Contract #: 04-0120F4Cty: SF/ALA Rte: 80 PM: 13.2/13.9File #: 69.25B**QUALITY ASSURANCE -- NON-CONFORMANCE REPORT****Location:** Changxing Island, Shanghai, China**Report No:** NCR-000819**Prime Contractor:** American Bridge/Fluor Enterprises, a JV**Date:** 29-Jul-2010**Submitting Contractor:** Zhenhua Port Machinery Company, Ltd (ZPMC), Changxing Island**NCR #:** ZPMC-0781**Type of problem:**

Reference Description: Mishandling Side Plates on Lift 13 resulting in Distortion of Members**Description of Non-Conformance:**

Subject: NCR No. ZPMC-0781

Job Name: SAS Superstructure

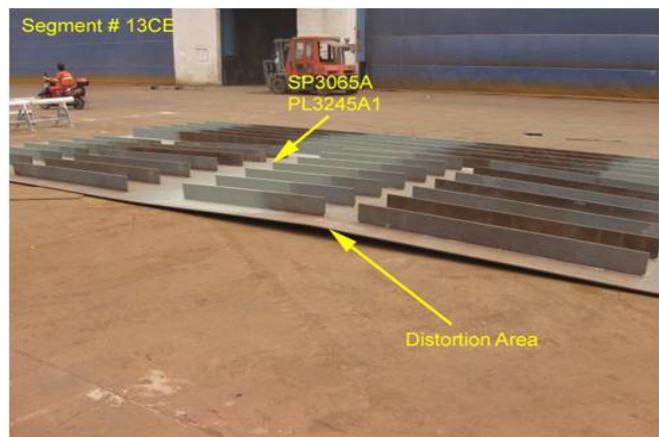
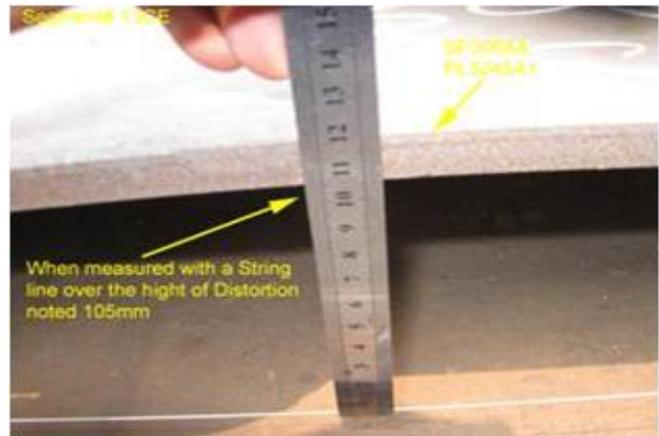
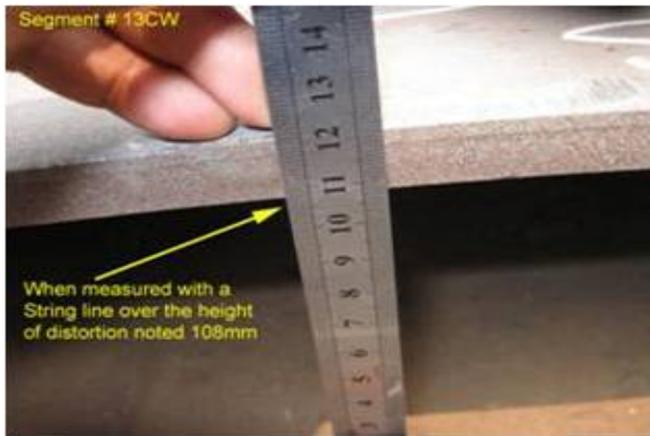
During random in process observations of the Blast Shop (1) of Side plate 13CE & 13CW, this Quality Assurance discovered the following issue:

- Side plates were observed being moved with lift truck (forks) using a center pick point and no additional support on either end of the Side Panel. The unsupported ends sagged significantly, causing the members to become distorted. Pieces were on ground without support and the following distortion was measured in this condition.
- The distortion measuring approximately 107mm from the Side plate 13CW.
- The distortion measuring approximately 105mm from the Side plate 13CE.
- The Side Plate is identified as 13CW: SP3097A-PL3389A (Non SPCM)
- The Side Plate is identified as 13CE: SP3065A-PL3245A1 (Non SPCM)
- The distortion was measured using a string Line and straight edge.
- Plate is located in the north side of Blast Shop (1).

For further information, please reference the attached pictures.

Standard Specifications July 1999, Section 55-1.04; "In handling of the steel work, every care shall be taken to avoid bending, scraping or overstressing the pieces. All pieces bent or otherwise injured will be rejected."

Standard Specifications July 1999, Section 55-3.09; "Finished members shall be true to line and free from twists, bends and open joints."

Reference Resolution: ZPMC has documented this internally with a NCR to make the department responsible for moving is aware that parts need to be supported while in transit to prevent future occurrences.

ZPMC has repaired the distortion using mechanical means and is providing the NDT done after to show that distortion caused during mishandling and the subsequent repair did not damage the welds. ZPMC has documented this internally with a NCR to make the department responsible for moving is aware that parts need to be supported while in transit to prevent future occurrences. If this becomes a systematic problem, ZPMC QA will conduct training and meet to discuss this with the department responsible. Based on this ZPMC requests closure of this NCR.

The NDT records of the mechanically straightened area and its adjacent area shall receive 100% MT rather than 10%.

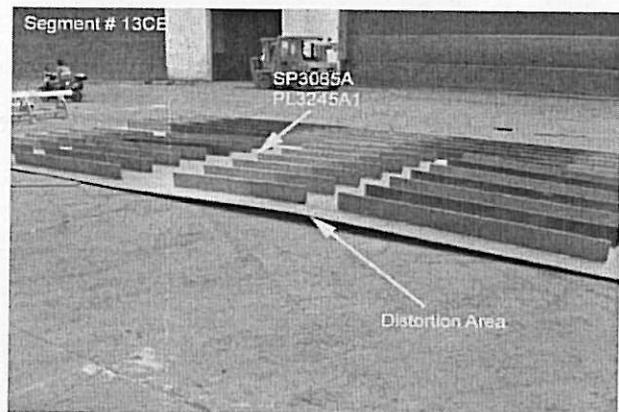
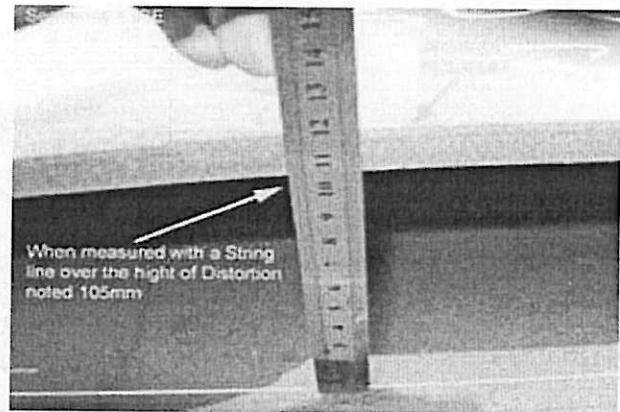
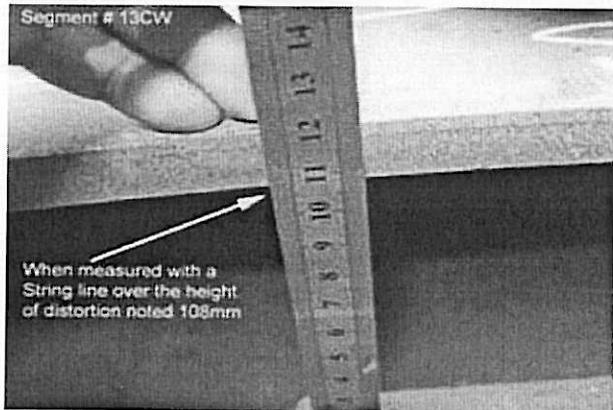
During random in process observations of the Blast Shop (1) of Side plate 13CE & 13CW, this Quality Assurance discovered the following issue:

-Side plates were observed being moved with lift truck (forks) using a center pick point and no additional support on either end of the Side Panel. The unsupported ends sagged significantly, causing the members to become distorted. Pieces were on ground without support and the following distortion was measured in this condition.

-The distortion measuring approximately 107mm from the Side plate 13CW.

-The distortion measuring approximately 105mm from the Side plate 13CE.

-The Side Plate is identified as 13CW: SP3097A-PL3389A (Non SPCM)

-The Side Plate is identified as 13CE: SP3065A-PL3245A1 (Non SPCM)

- The distortion was measured using a string Line and straight edge.

For further information, please reference the attached pictures.

The previously submitted report documents the MT of the percentage of the weld affected by the mechanical straightening. 10% of the entire weld length was tested which accounted for 100% of the area affected by the straightening, the remaining 90% of the weld was not near the distorted area. Based on ZPMC's clarification, ZPMC requests closure of this NCR.

Contractor stated that the NDT area covers the area of concern, and the Department has also performed QA inspection. This NCR is closed.

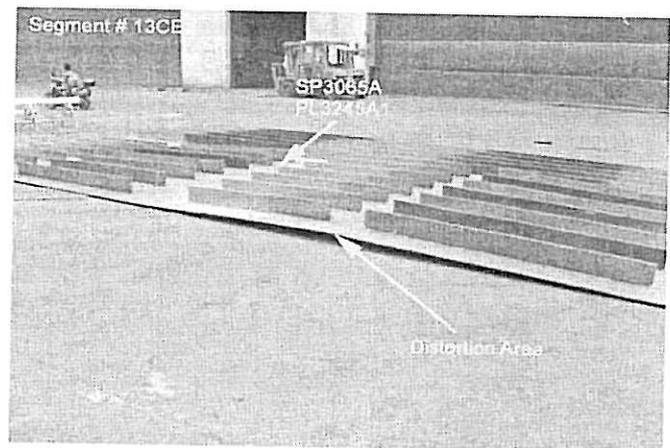
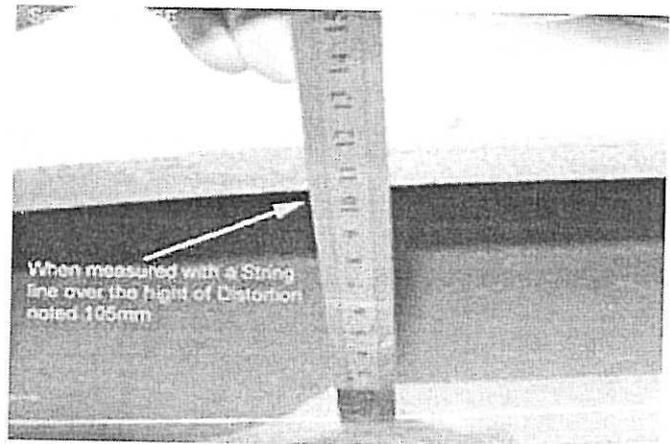
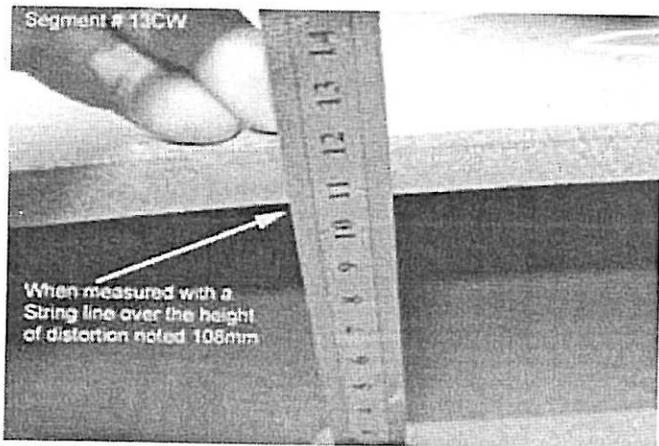
During random in process observations of the Blast Shop (1) of Side plate 13CE & 13CW, this Quality Assurance discovered the following issue:

- Side plates were observed being moved with lift truck (forks) using a center pick point and no additional support on either end of the Side Panel. The unsupported ends sagged significantly, causing the members to become distorted. Pieces were on ground without support and the following distortion was measured in this condition.
- The distortion measuring approximately 107mm from the Side plate 13CW.
- The distortion measuring approximately 105mm from the Side plate 13CE.
- The Side Plate is identified as 13CW: SP3097A-PL3389A (Non SPCM)
- The Side Plate is identified as 13CE: SP3065A-PL3245A1 (Non SPCM)
- The distortion was measured using a string Line and straight edge.
- Plate is located in the north side of Blast Shop (1).

For further information, please reference the attached pictures.

ZPMC QA personnel have issued an internal NCR to address this problem.

Contractor will address the flatness issue by mechanical method and provide subsequent NDT verification.

ZPMC performed mechanical straightening and provided NDT verification records to the affected area.
